**FINDINGS AND RECOMMENDATION  
OFFICE OF PLANNING AND ZONING  
ANNE ARUNDEL COUNTY, MARYLAND**

**CASE NUMBER:** 2024-0198-V

The applicant is requesting a variance to allow a dwelling with less setbacks and buffer than required on property known as 260 Magothy Boulevard (Tax ID 3881-2548-6565) in Pasadena.

**VARIANCE SITE PLAN**  
 BUFFER DISTURBANCE PLAN  
**MAGOGHY BEACH**  
**Lot 348R**  
 174 MAG 24 080 15 PAVES COUNTY, MD 21222  
 300 Magoghy Beach, Pasadena, MD 21222  
 348 ASSESSMENT DISTRICT, ANNE ARUNDEL COUNTY, MARYLAND 21222  
 SCALE: 1" = 20'  
 DATE: OCTOBER, 2024

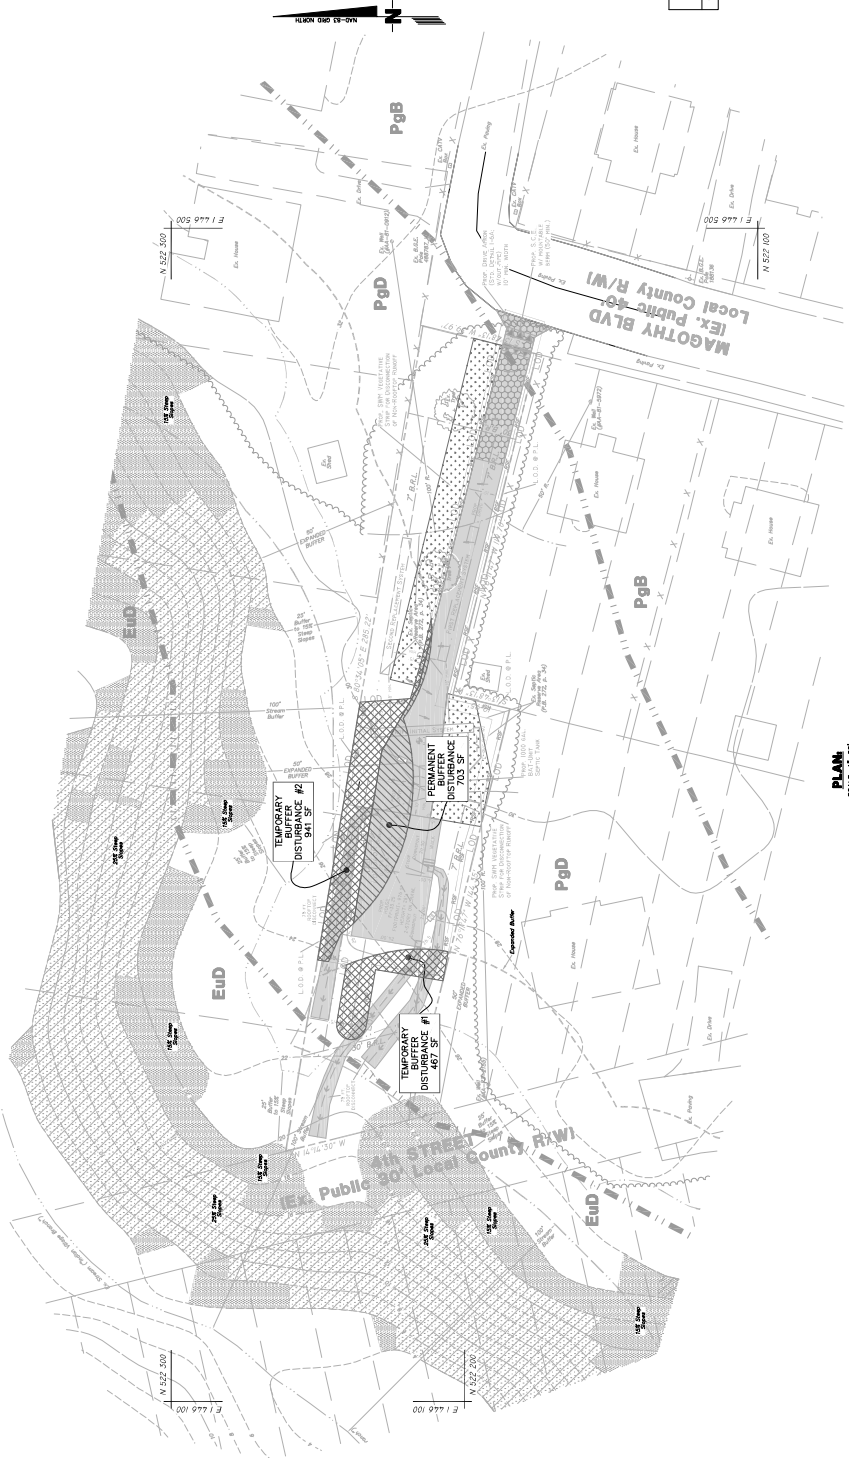
- Stormwater management will be addressed through three rooftop disconnections and non-rooftop disconnections.
- The County Practices and Procedures Manual requires that pre and post-drainage area maps should have elevations clearly labeled and contour lines must extend a minimum of 200 feet beyond the delineated area. Per County Code § 16-3-209 (a).

- Add proposed spot elevations along the disconnection flow path to ensure the slopes are 5% or less so the contractor can grade the disconnection and the property properly.

- The contributory drainage area to each non-rooftop disconnection area may not exceed 1000 SF.
- The contributory roof drainage area to each 75-foot rooftop disconnection area may not exceed 500 SF.

- Provide additional spot elevations on the disconnections flow path to make sure that the pervious disconnection flow path area works/flows as intended.

- Regarding site grading, existing and proposed elevation, elevation changes (especially on "flat" sites with little to no grade relief, impacts to neighboring properties, or accounting for offsite runoff as a part of the site design).

- All stormwater conveyance systems shall be designed so that no building or habitable structure, either proposed or existing, is flooded or has water impounded against it during the 100-year storm event.

- Per 6.1.4 (G) of the County Stormwater Practices and Procedures manual, the SWM facilities shall not be located in areas that are off-limits to development, e.g., natural resource areas and their steep slopes and buffers.

- Ensure the proposed improvement including runoff, seepage, and slope saturation does not adversely impact the integrity of the slope and potential impact of slope failure.

- Based on the plan provided, it appears that the property will be served by a private septic and well.
- Based on the above comments and proposed site design, this office does not support this request.
